Cottam Solar Project

Figure 8.16.1: Landscape and Ecology Mitigation and Enhancement Plan – Cottam 1 North (Sheet 1) Revision A

Document reference: EX1/C6.4.8.16.1_A

Figure 8.16.1
Cottam 1 North (Sheet 1)
Landscape and Ecology Mitigation and Enhancement Plan
[EN010133/EX1/C.6.4.8.16.1.A]

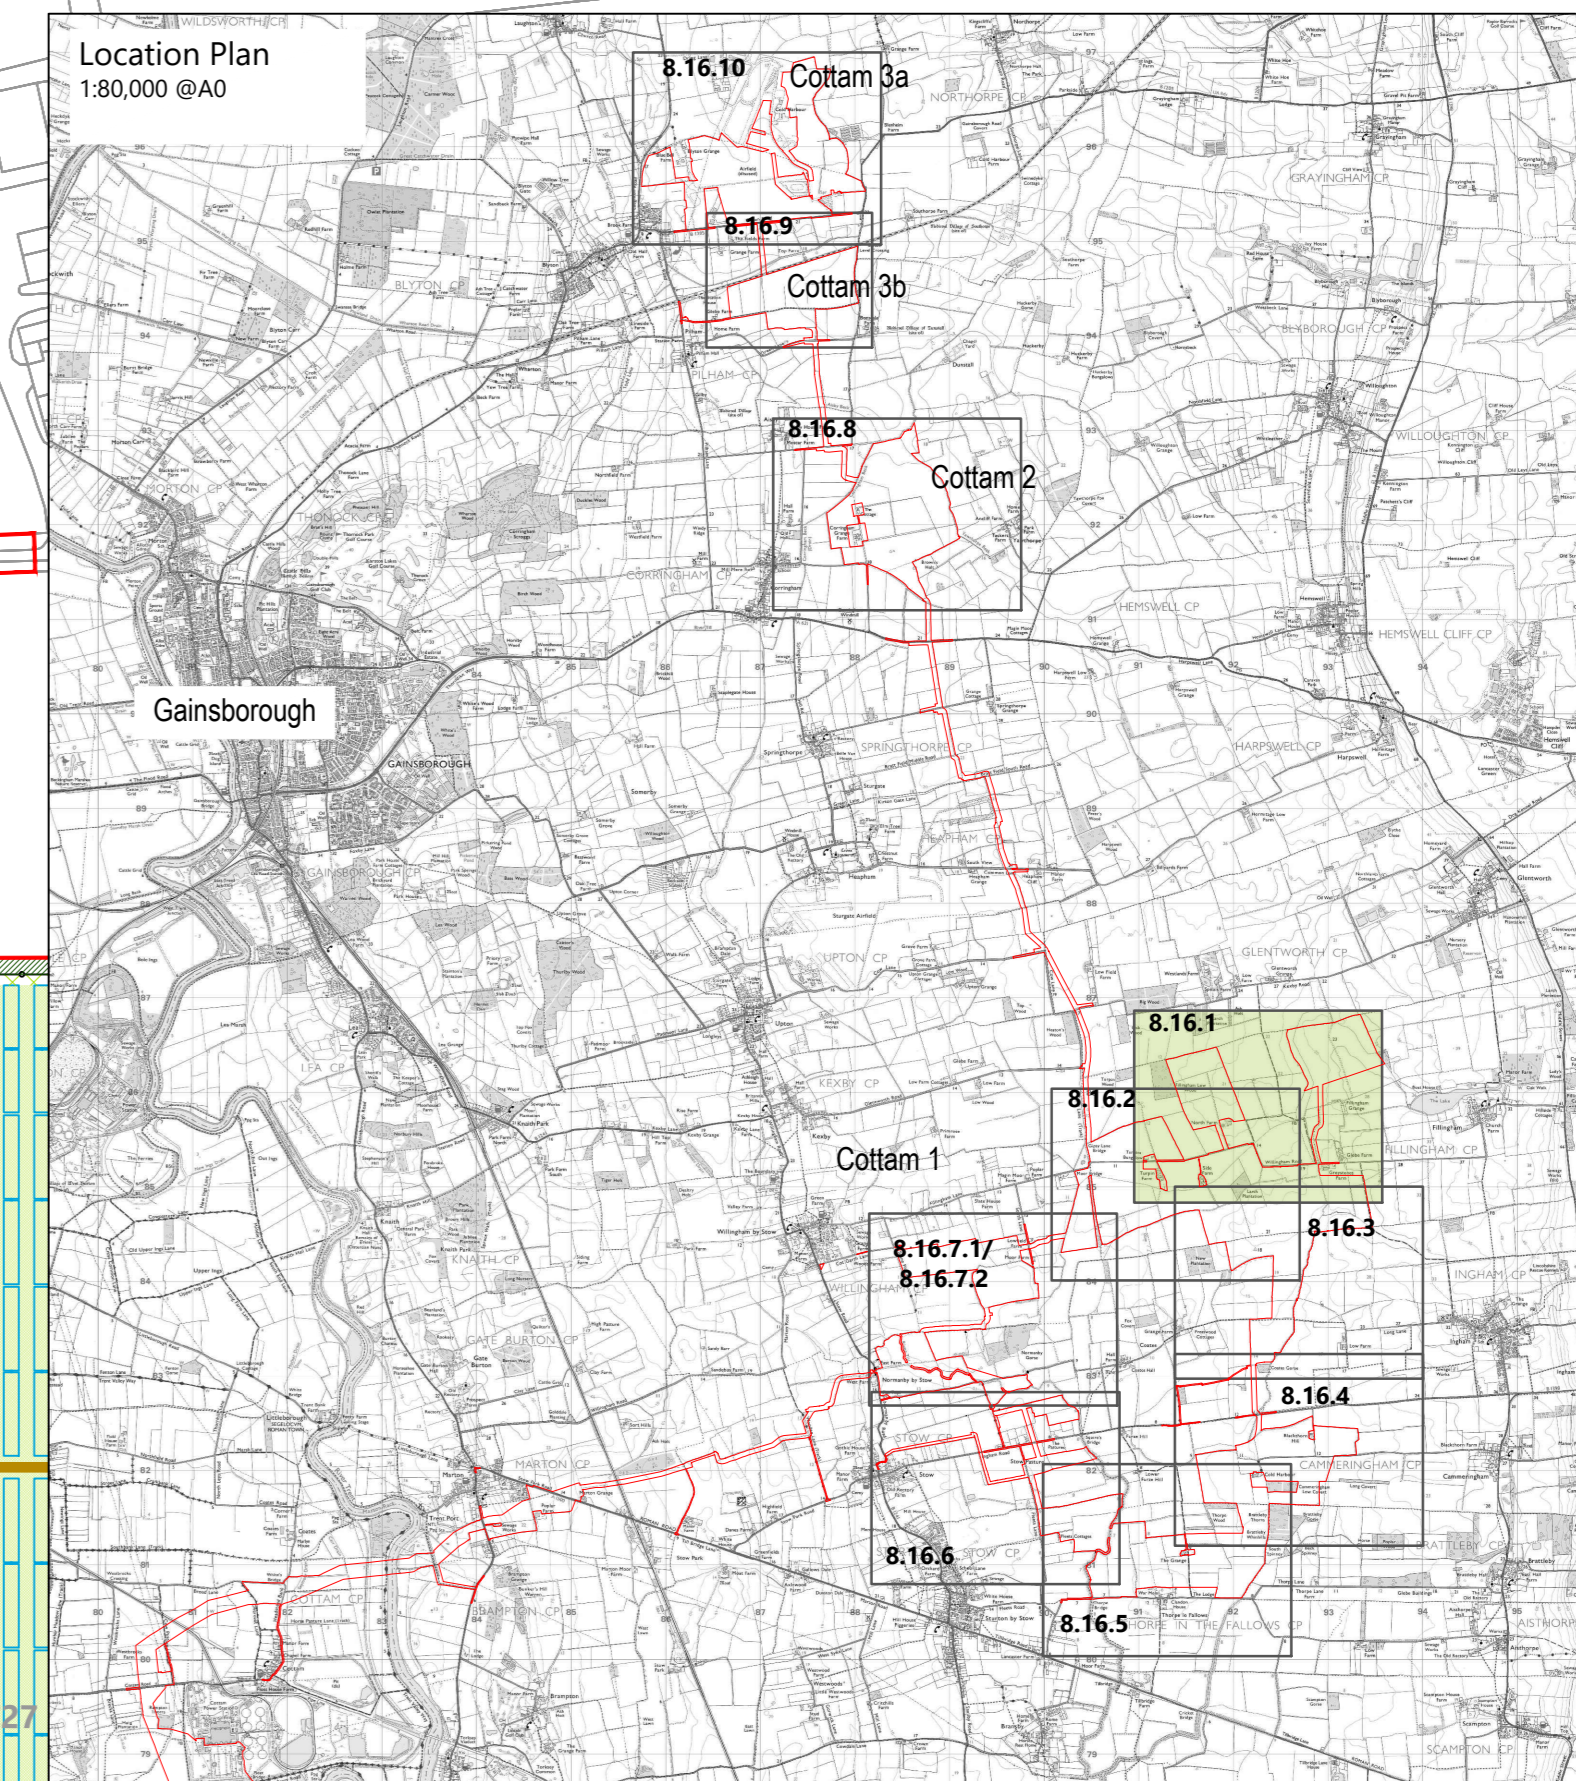
Figure Reference	Page	Description of Changes	Reason for Revision
Figure 8.16.1	3	Change to spelling of 'enhancement'. Offset calculations from drains.	For clarity and to correct a typo.
